3200 Reid's Lane Subdivision Conceptual Servicing and Stormwater Management Report

**Re: Conceptual Servicing and Stormwater Management Report
Reid's Lane Subdivision
3200 Reid's Lane, Ottawa, ON
Response to Comments
Our File No.: 119089**

Re: Draft Plan of Subdivision Application – 3200 Reid’s Lane (1st review)

LOCATION CITY OF OTTAWA REID'S LANE SUBDIVISION		PROJECT No. 119089
DRAWING NAME PRELIMINARY GRADING & SITE SERVICING PLAN		REV # 6
		DRAWING No. 119089-PGR

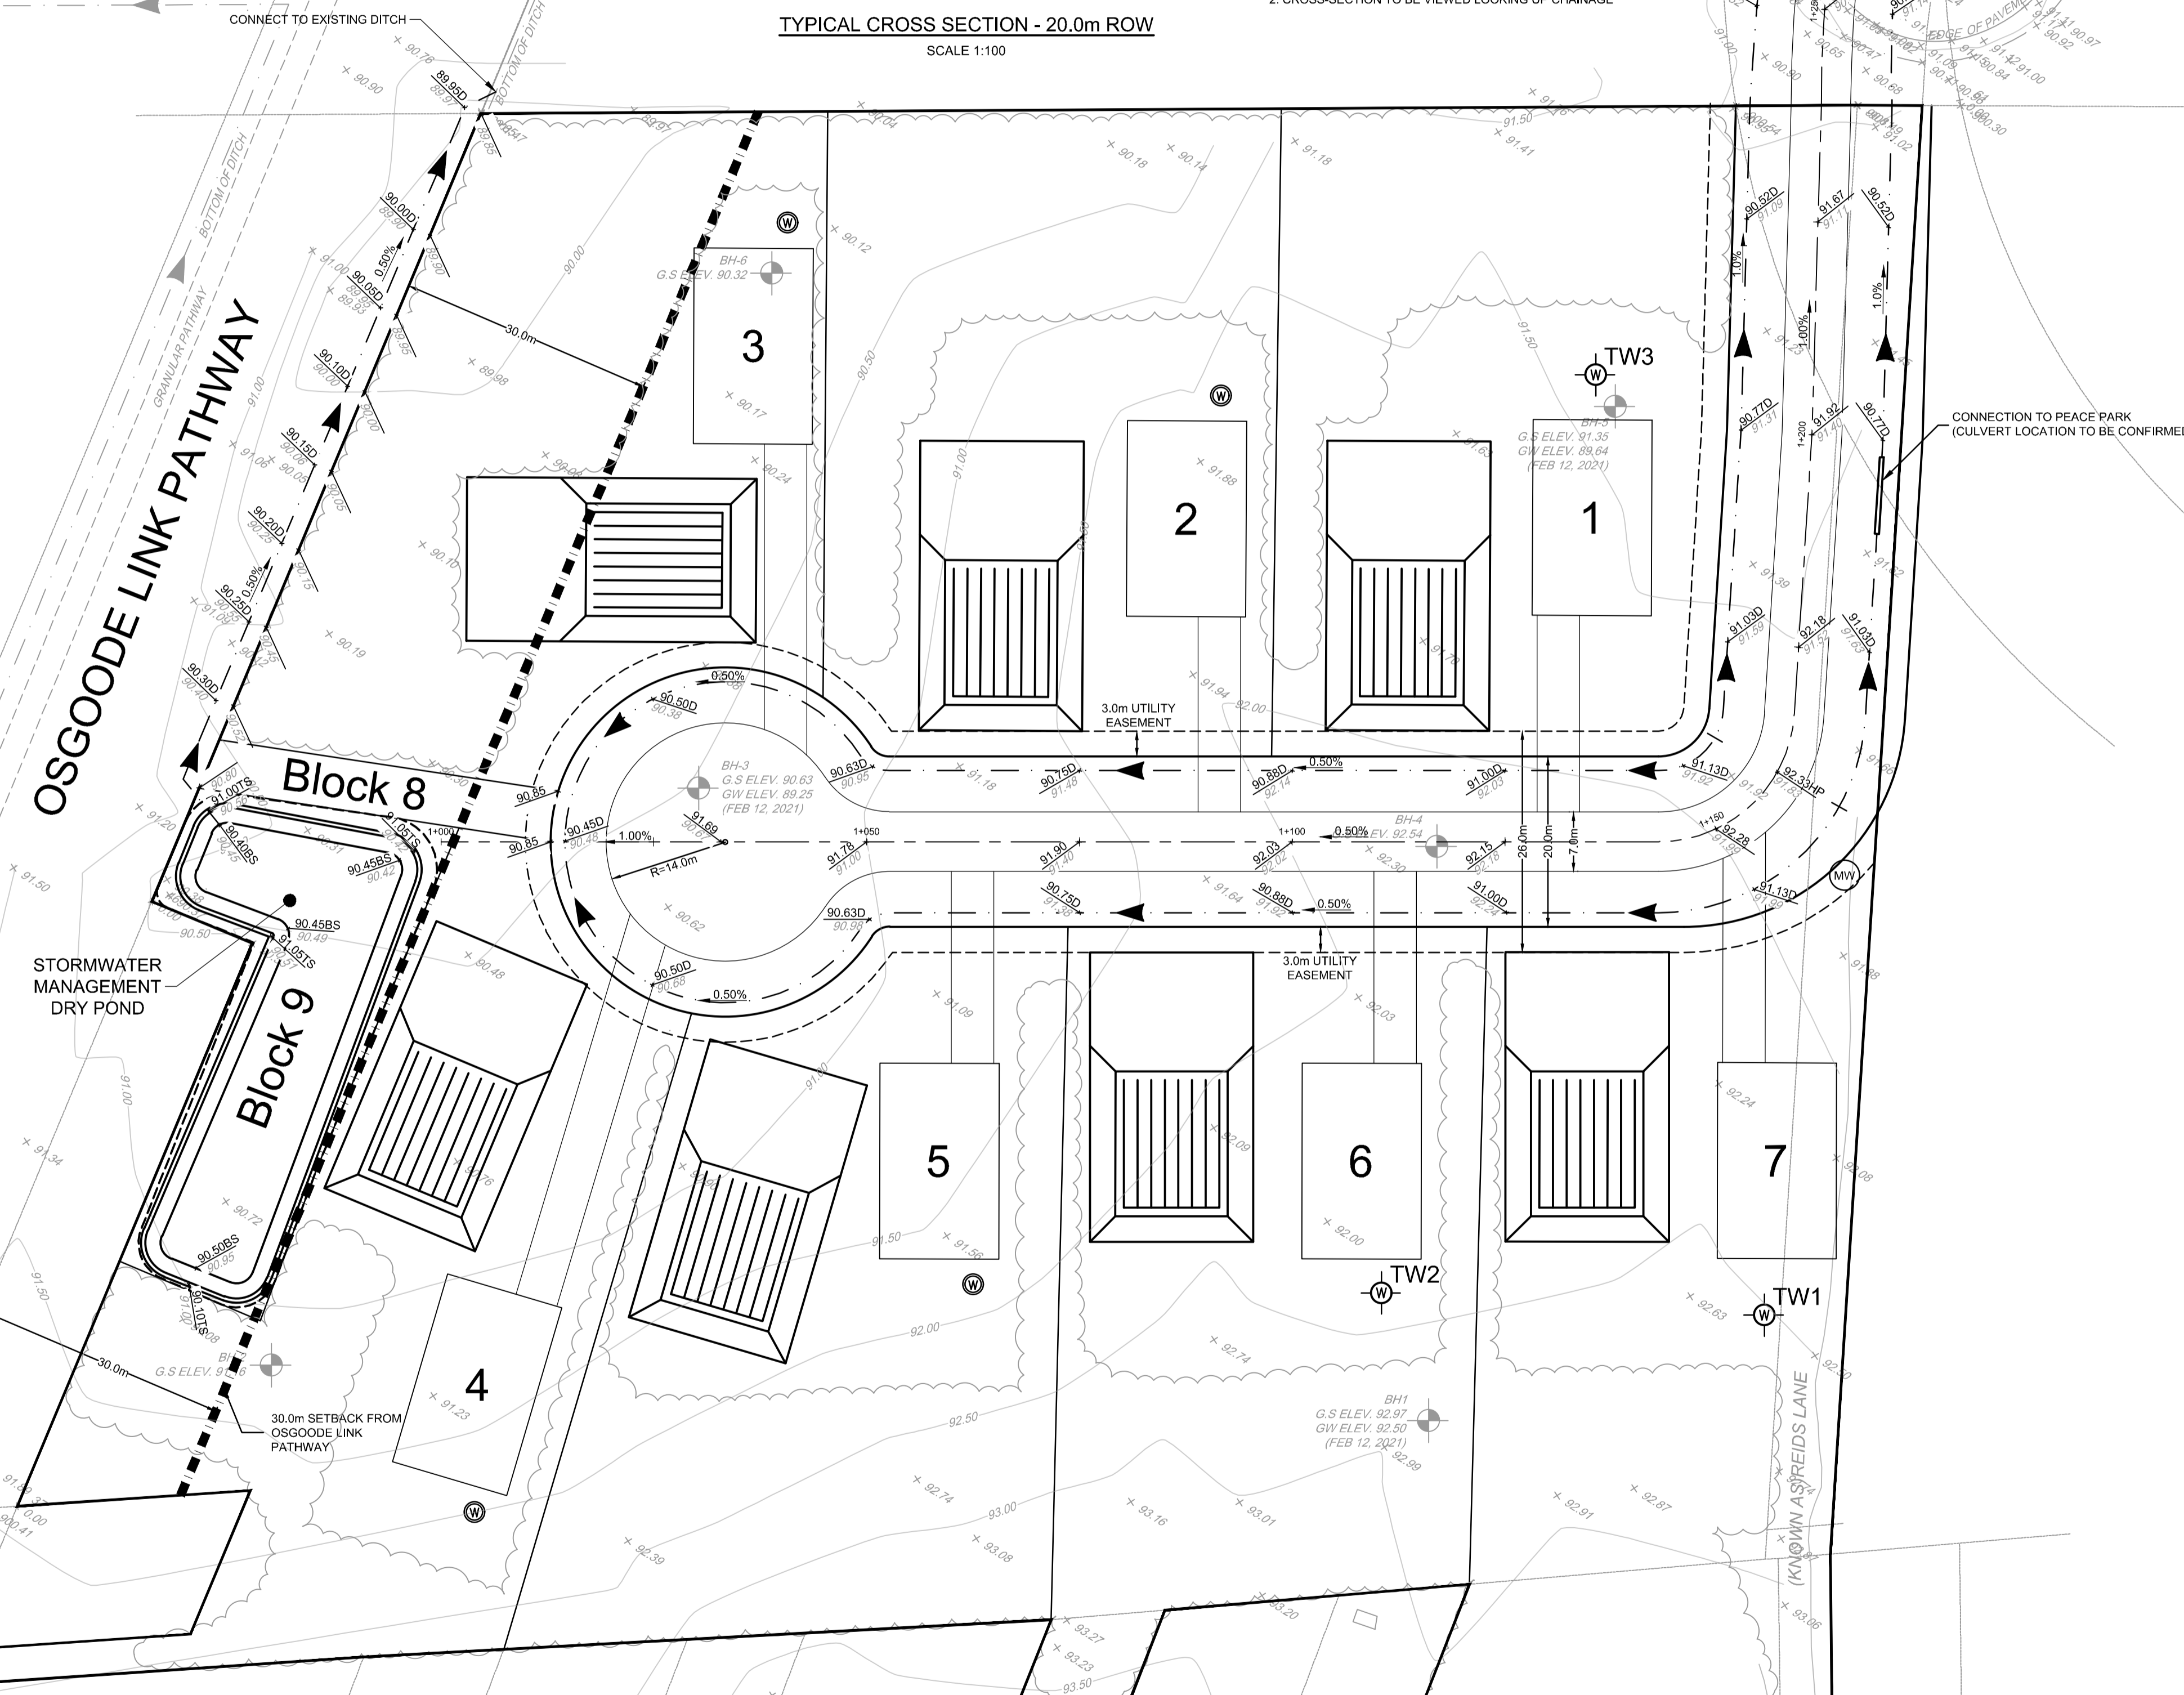
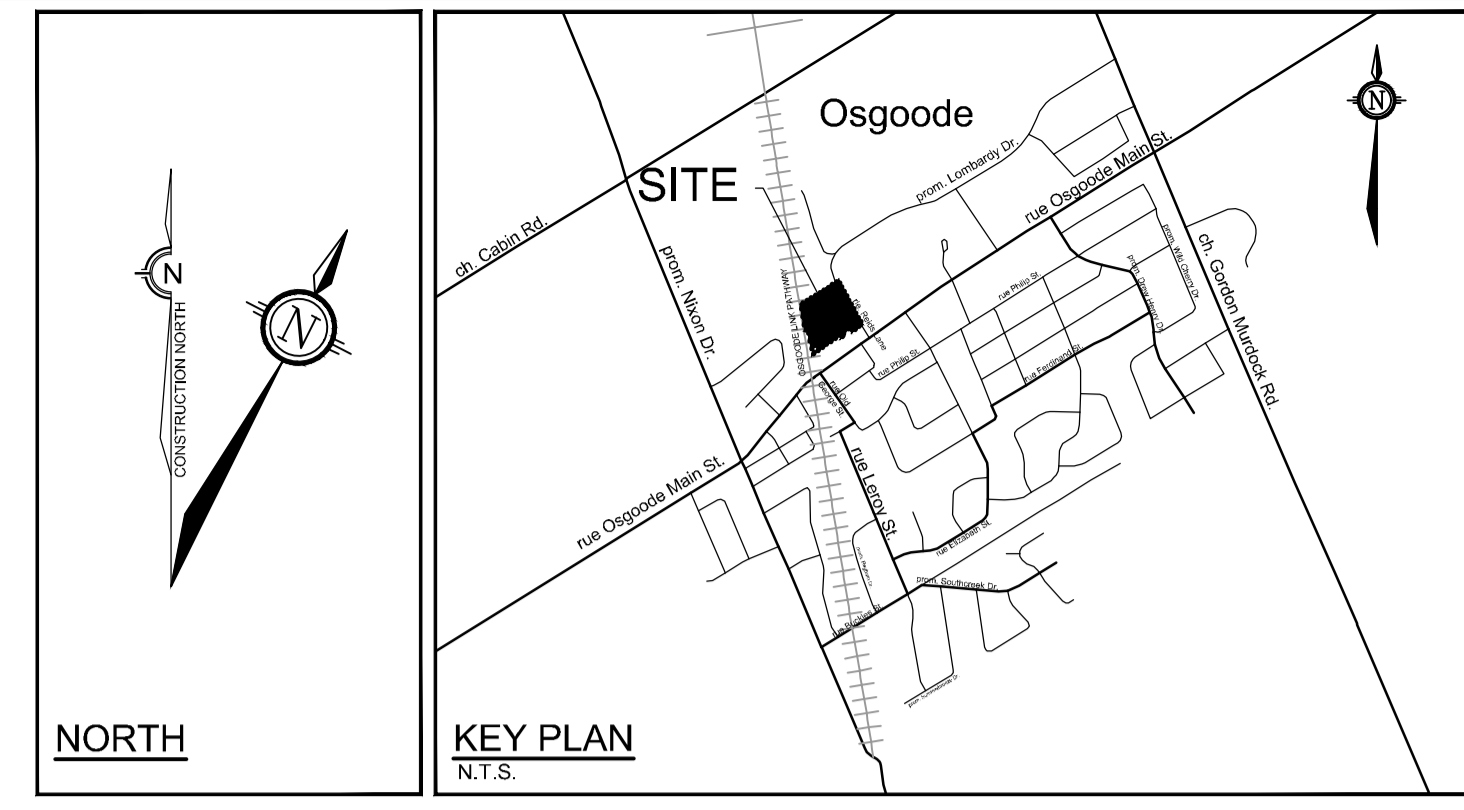
Preliminary Grading Plan, 119089-PGR, prepared by Novatech Engineering, dated Sept 03/21.

21. Please ensure this plan coordinates with the EIS and Tree Conservation Report to maximize tree retention.
